# Updating Link Budget with Addition of 1T DFE

(Comments 132, 134, 135, 136, 137, 138, 139, 140, and 141)

**Ali Ghiasi - Ghiasi Quantum/Marvell**

**IEEE 802.3dj Interim Meeting  
Minneapolis**

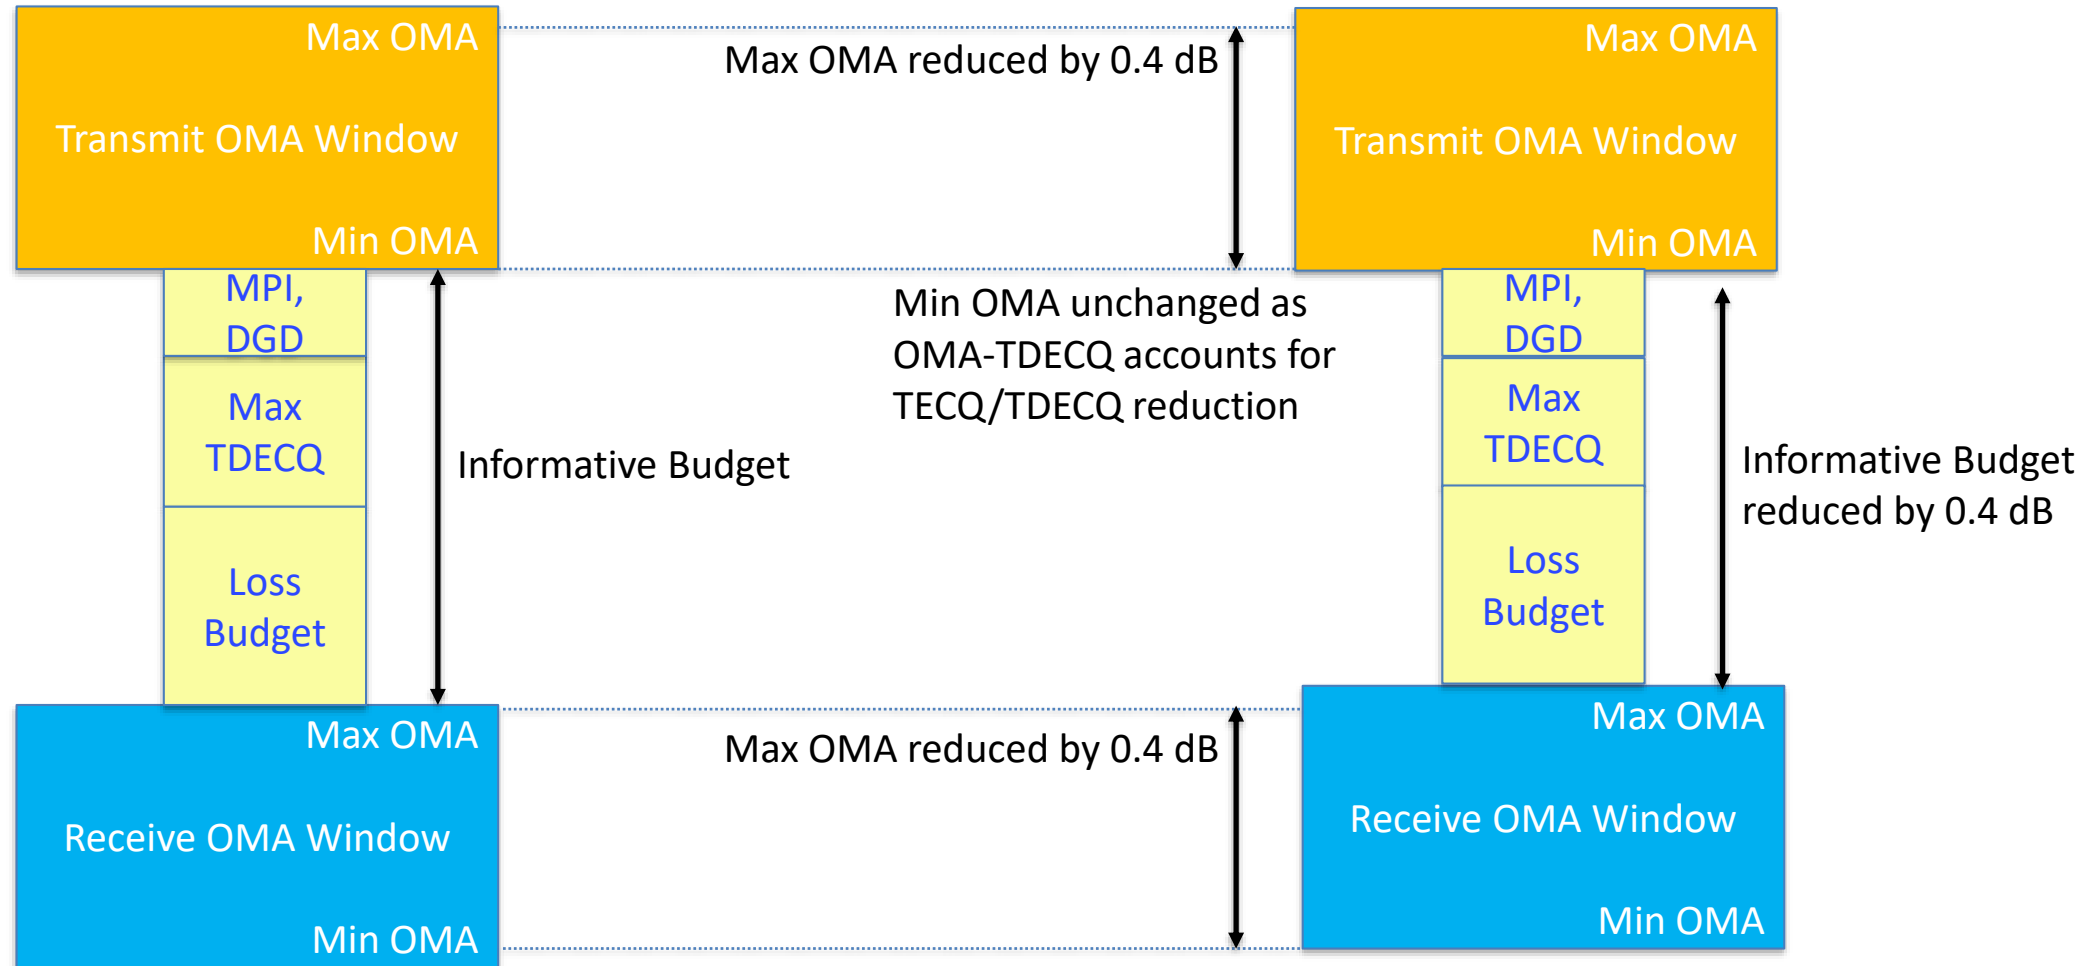
- 0.4 dB TDECQ reduction benefit is split between transmitter and receiver
